BARNES & NOBLE

3173 CINEMA POINT,
COLORADO SPRINGS, CO 80922

Project Number 33288
Store Number 3566

Date	Description	No.
04-25-25	ISSUED FOR PERMIT, BID, LANDLORD & CLIENT REVIEW	1
06-12-25	LL AND BD COMMENTS	2
07-23-25	BD COMMENTS	3
08-8-25	BD COMMENTS	4

1 Mechanical Plan
M-102 SCALE: 1/8" = 1'-0"

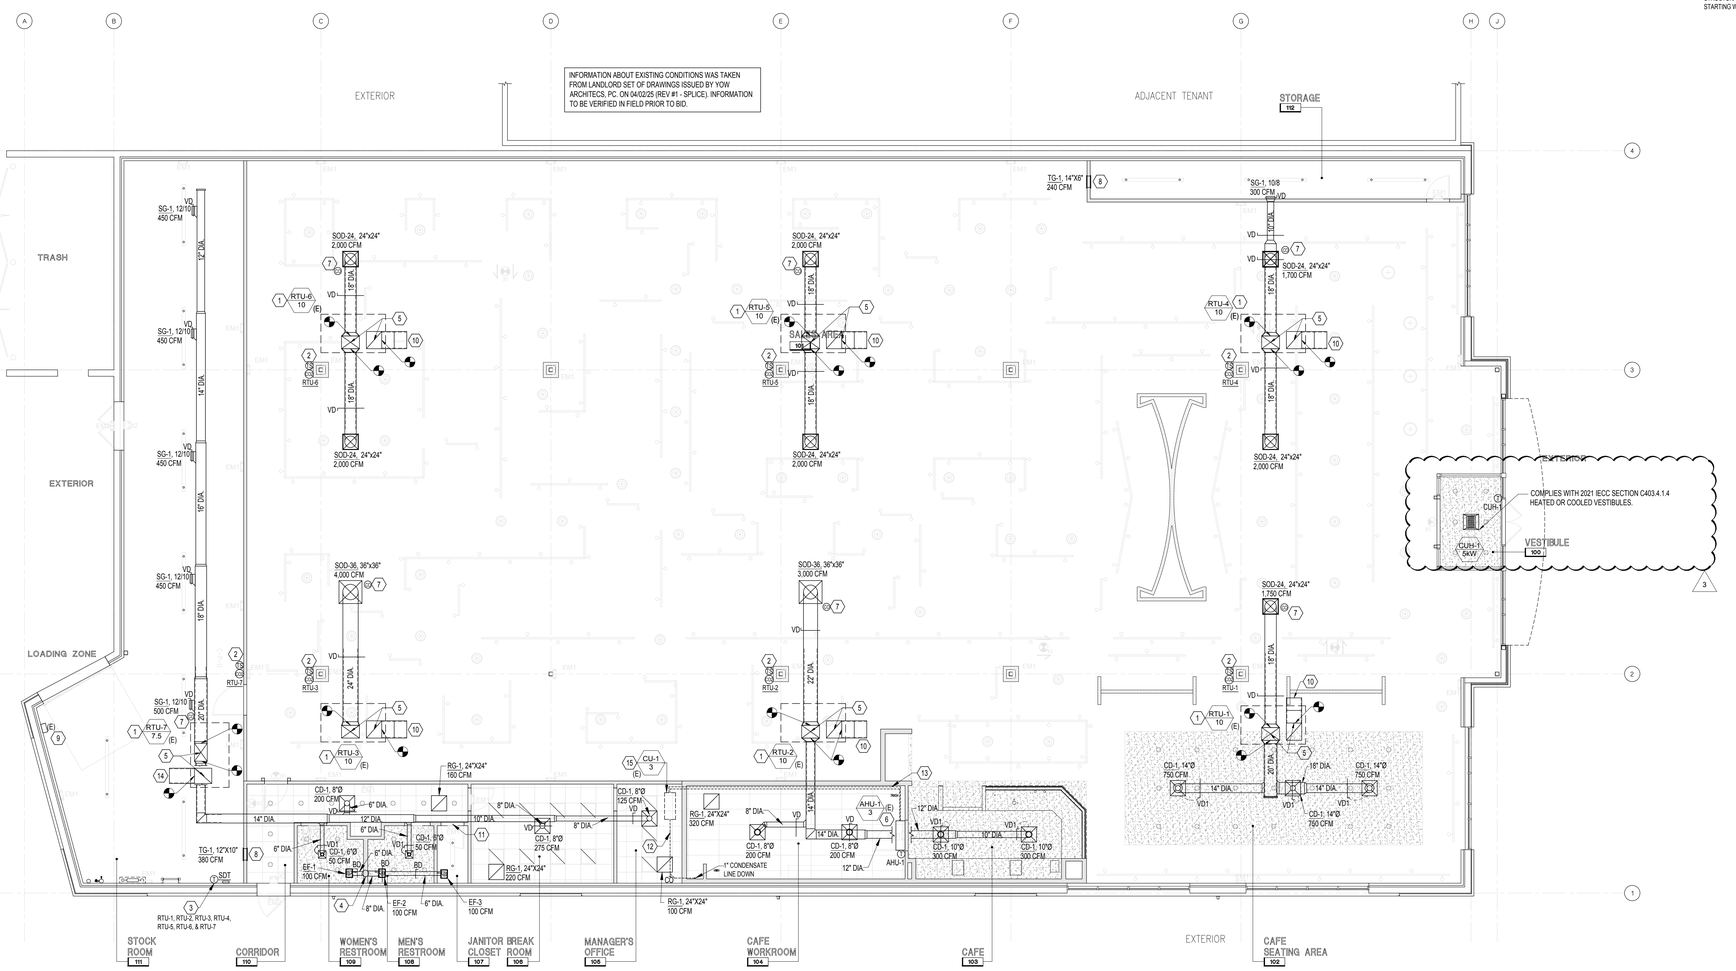
48	M-102	Added note to vestibule.
49	M-201	Added note to vestibule heater.
50	M-301	No changes.
51	M-302	No changes.
52	M-303	No changes.
53	P-101A	Revised Note C to reflect 2021 IPC 403.1. Added note that the recirculation line on the hot water allowed the lavatories to comply with 2021 IPC Section C404.5.1.
54	P-101B	No changes.
55	P-101C	No changes.
56	P-102A	Added note on P-101A that the recirculation line on the hot water allowed the lavatories to comply with 2021 IPC Section C404.5.1.
57	P-102B	No changes.
58	P-102C	No changes.
59	P-102D	No changes.
60	P-201	No changes
